THE LANDMARK HOTEL
CHARLOTTESVILLE, VIRGINIA

MINOR FAMILY HOTELS
THE LANDMARK HOTEL
OCTOBER 2008

MAIN STREET ELEVATION COMPARISON

EAST ELEVATION COMPARISON

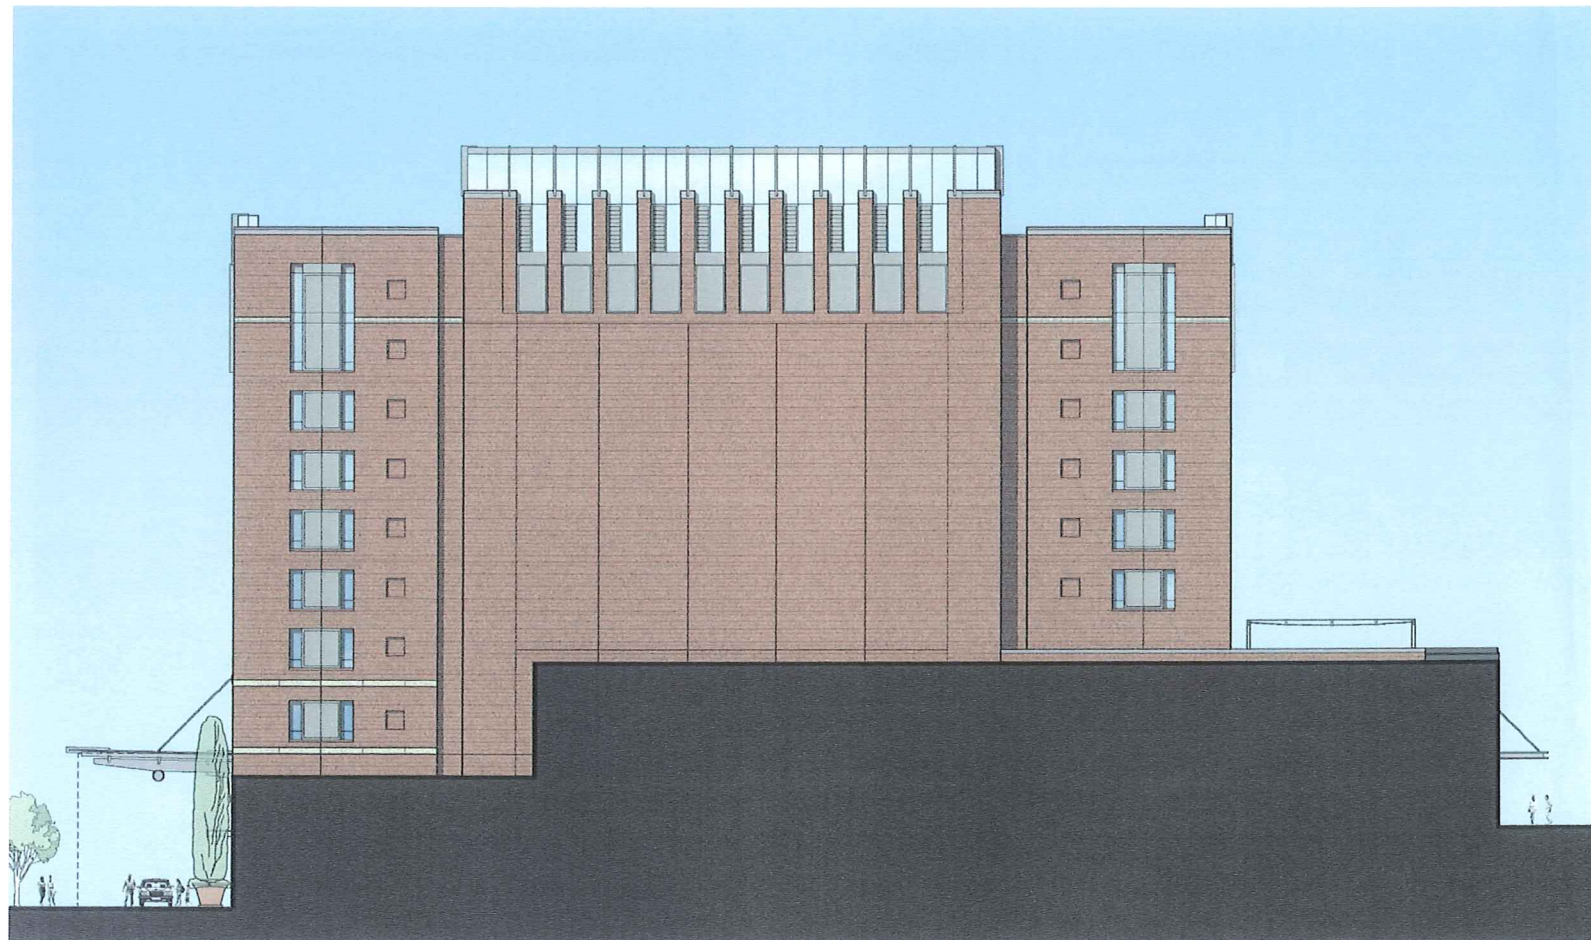
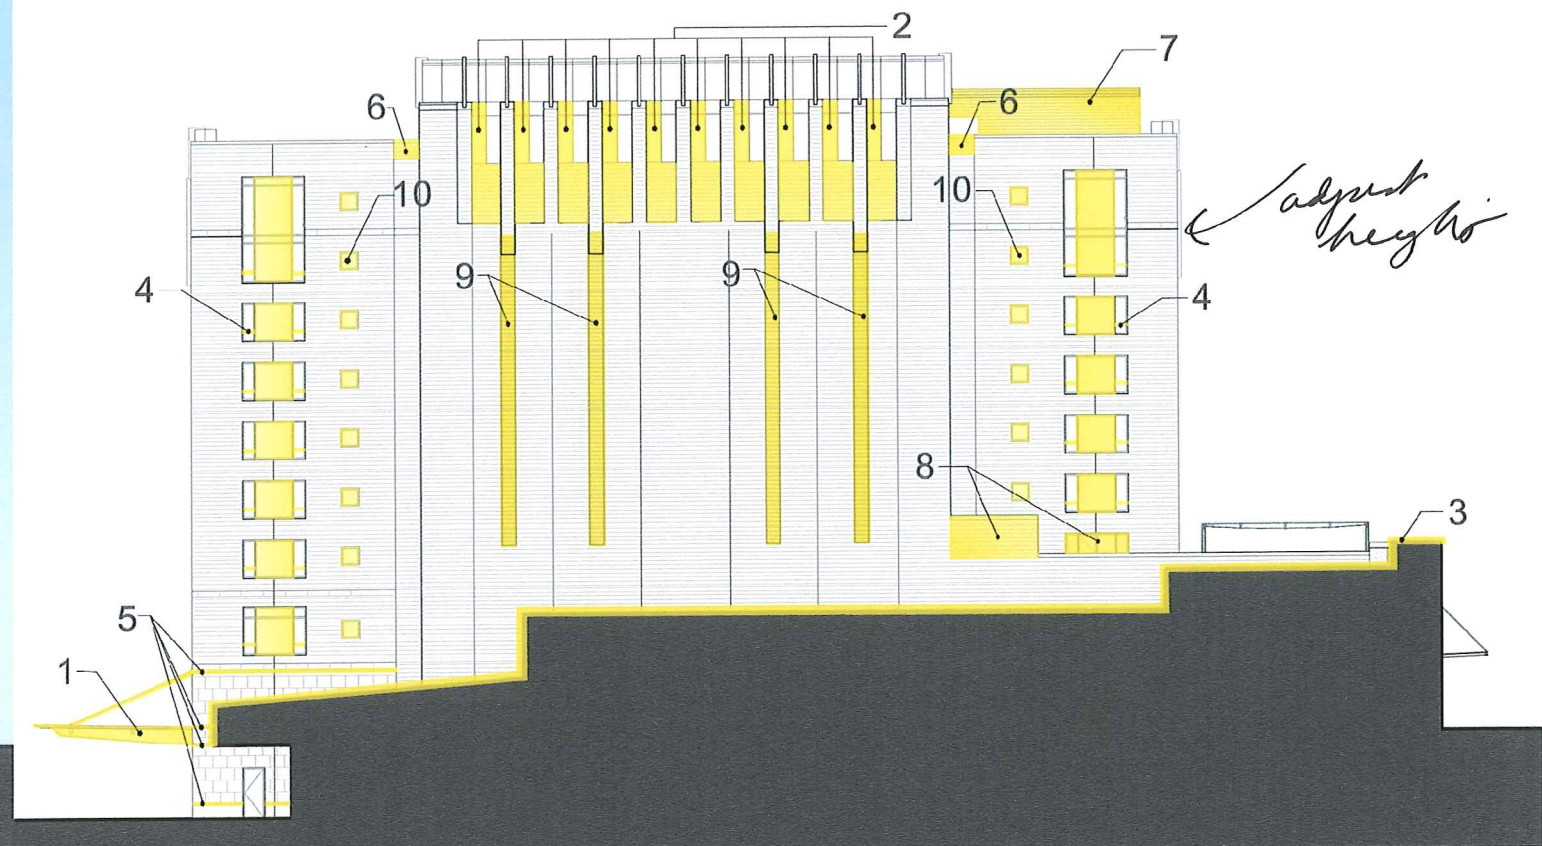
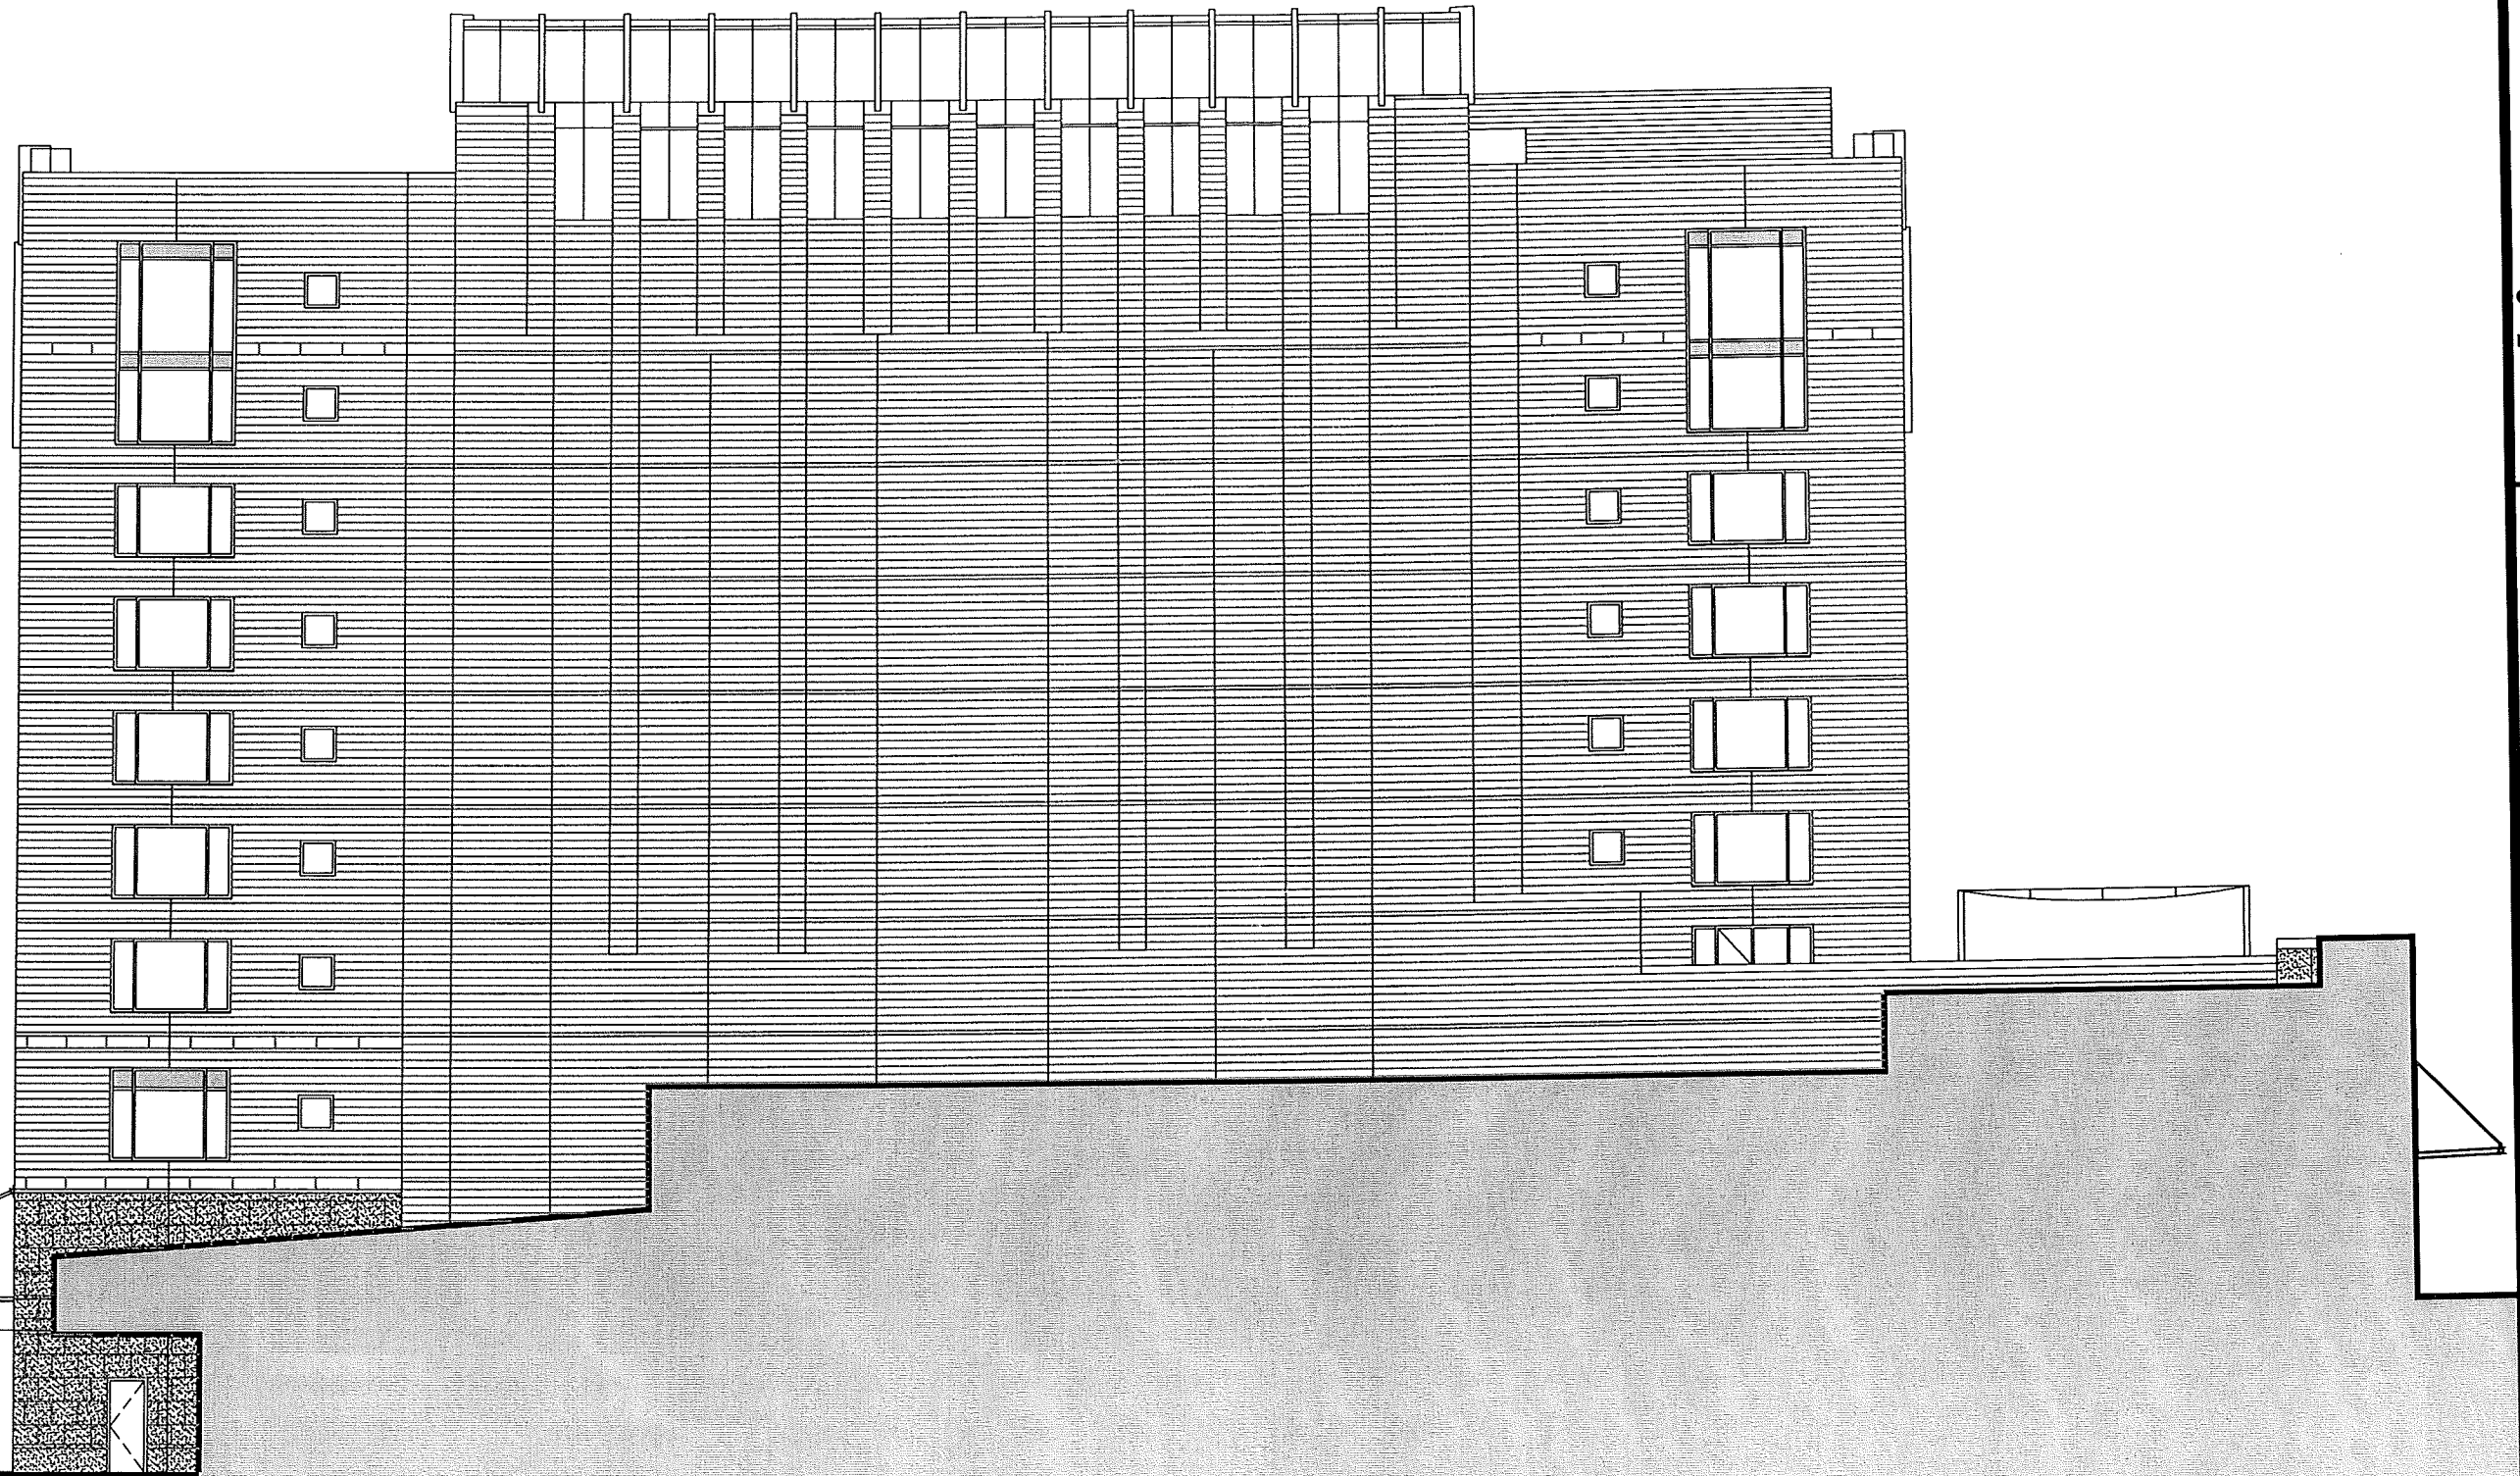
1/2" reveals

1. Canopy redesigned-
The canopy was changed and lowered through BAR approval.
2. Reduction of metal louvers- The louvers now show as glazing. *OK*
The louvers did not serve a function and it was replaced with glazing.

3. CVS party wall change-
The re-evaluation of the existing CVS party wall has been revised to show actual conditions. Since it was inaccurate in the original submission, the correct slope now shown will have modified some of the materials inaccurately shown near the Water street portion of this elevation. *OK*

4. Window/Butt glazed joint modification- *OK*
The guestroom windows previously had butt glazed joints shown. The joints were removed to avoid unsightly silicone sealant joints with clear glass. The windows were previously shown as metal panel and now are shown as glazing

5. Brick Insert banding- Row directly above canopy raised to accommodate the relationship between the canopy and the façade. Bands changed from red brick to precast inserts to match adjacent precast. *adjust height*
Differences in materials working against each other in expansion/contraction will ultimately cause problems with cracking.

6. Addition of parapet- *condition to make it open - glass or metal rail*
Original design did not take into consideration that people would be walking on the terrace and would need a barrier for safety.

7. Screen Wall- A mechanical screen wall was added through BAR approval to mask the mechanical units that service this building. *OK*
The screen wall height is adjusted to accommodate the actual mechanical units to be used.

8. Addition of pantry room bump out- *OK*
A bump out was added to accommodate the necessity for a pantry and storage for servicing the terrace.

9. Brick detail addition- The brick "columns" from the light box were adjusted to stretch further down this elevation.
The unadorned blank brick wall needed detail to break of the monotony of the blank wall.
10. Brick Recess to Small Windows- The brick recesses adjacent to guestroom windows are now replaced by windows.
The small windows now serve the guestrooms to allow natural light in as well as match the Second Street elevation in look and function.
